PROPOSED RENOVATION FOR:

**THOMAS PALMISANO**  
1312 SEVENTH AVENUE  
TOWNSHIP OF NEPTUNE, NEW JERSEY  
BLOCK: 416 | LOT: 6

PROJECT NO. AD19.125  
**COVER SHEET**  
SHEET  
**A1**  
OF 8 TOTAL

2 PROPOSED - FOUNDATION PLAN  
SCALE: 1/4" = 1'-0"

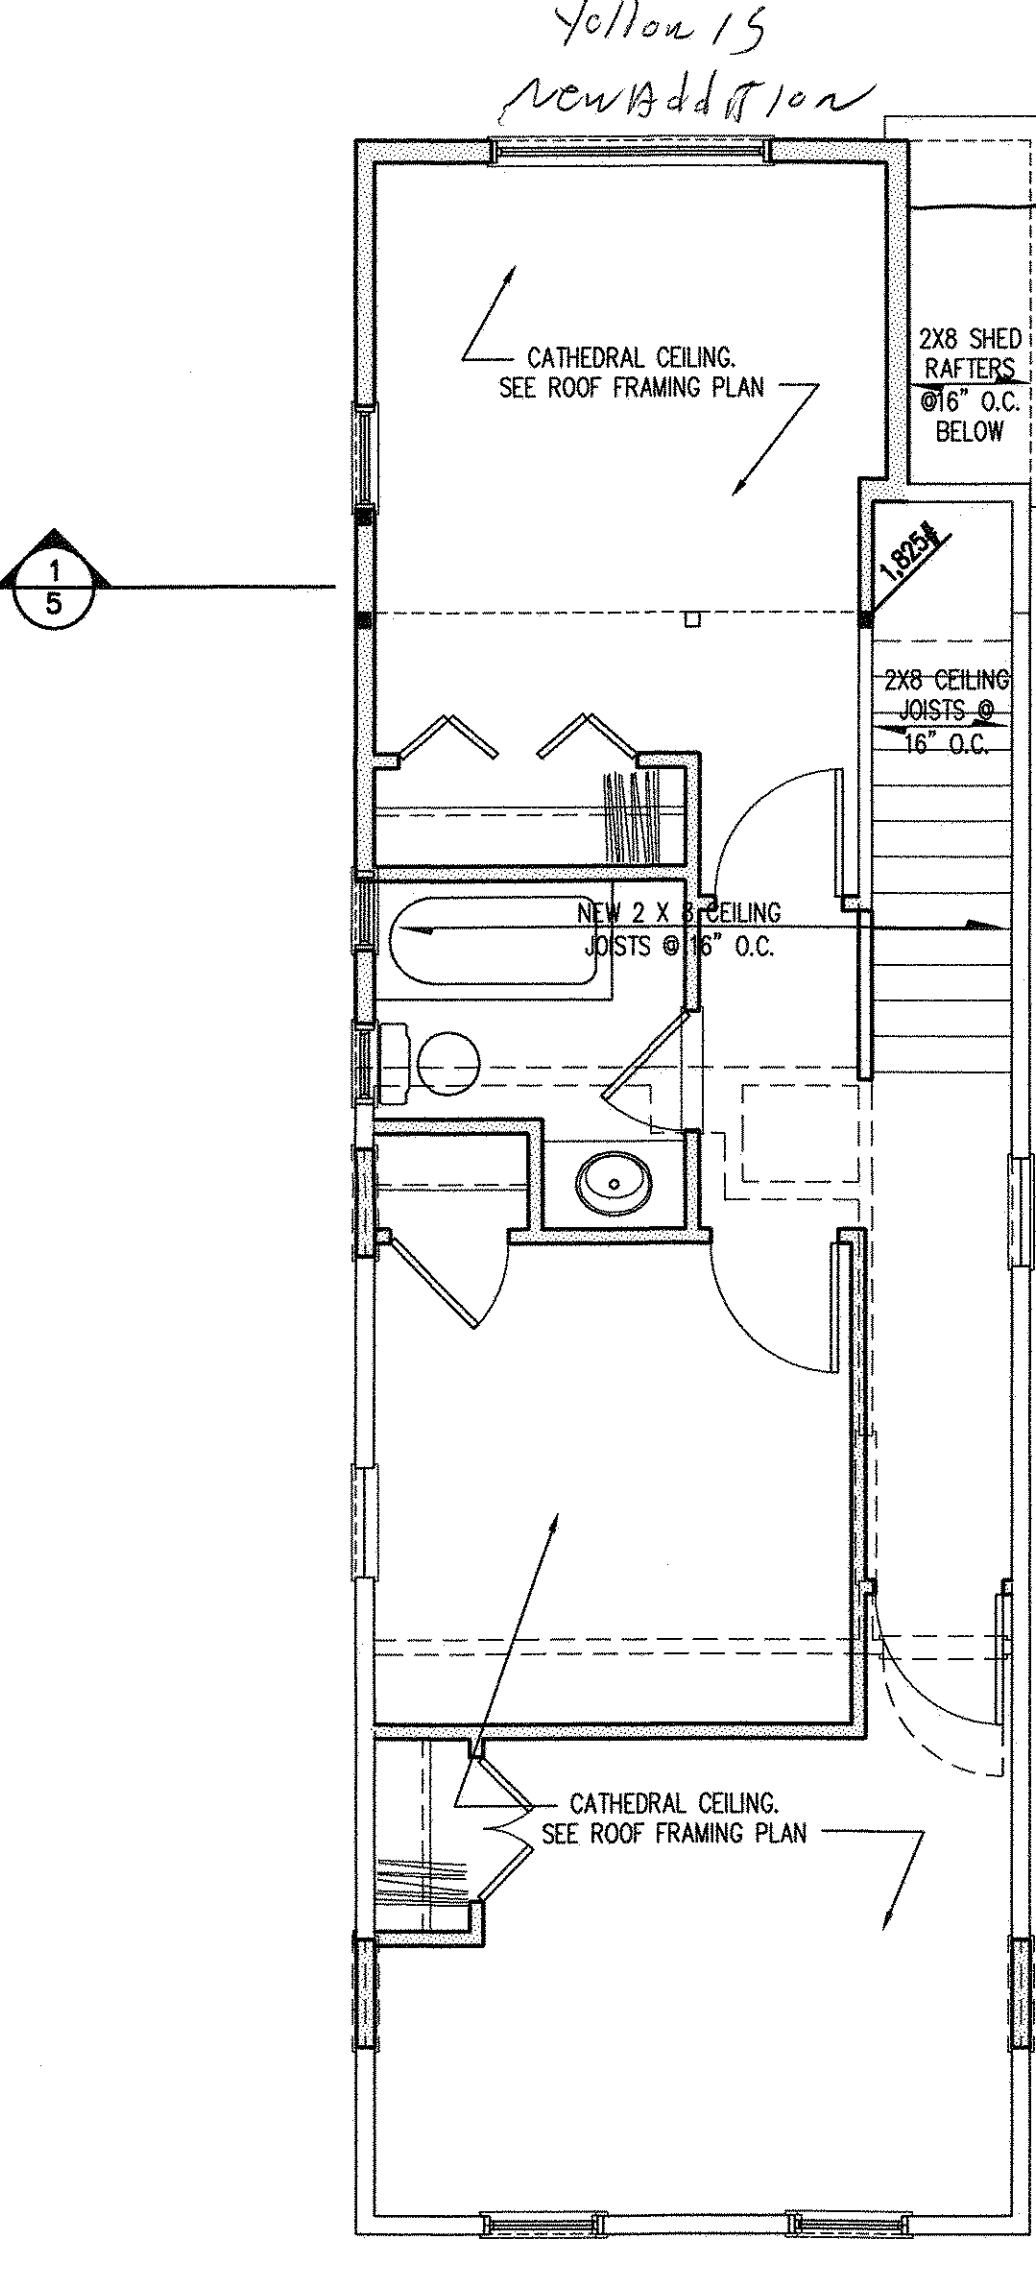
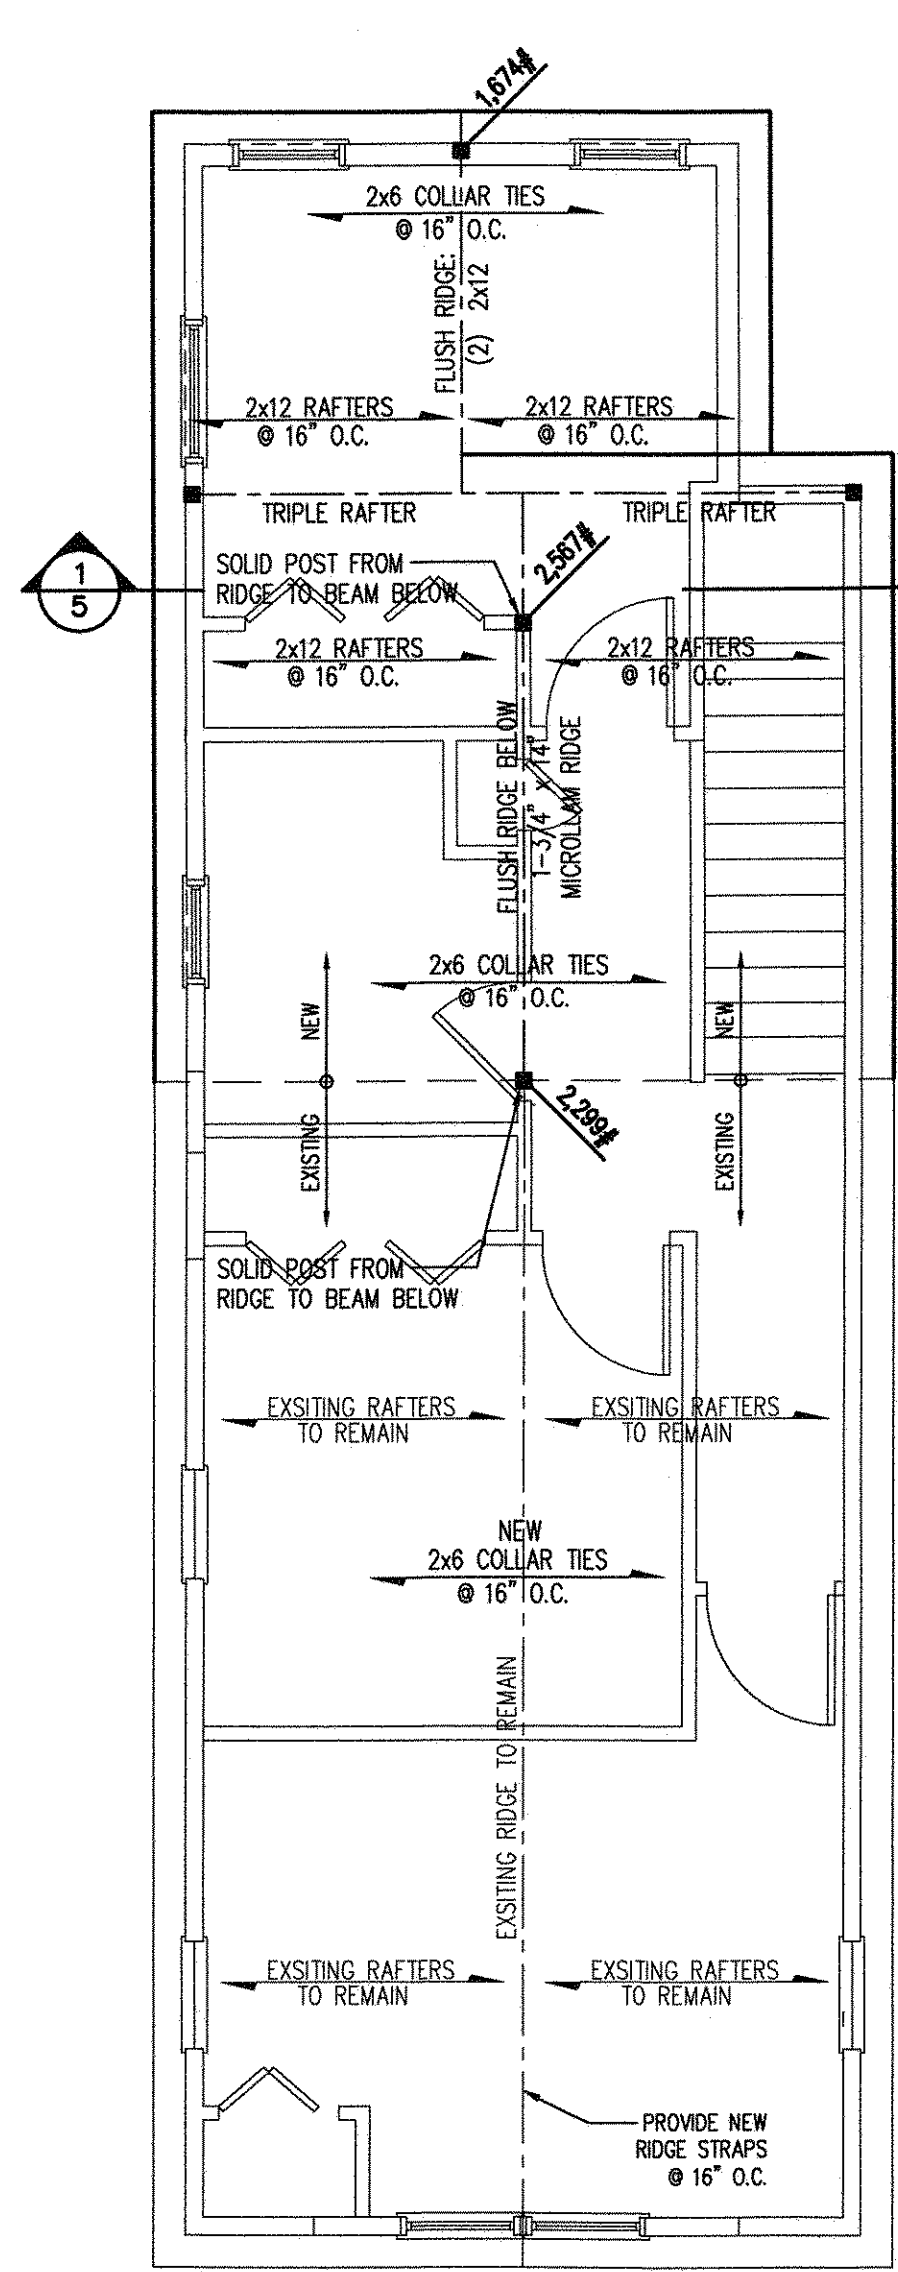
CJT BACK TO meet 5' req SETBACK
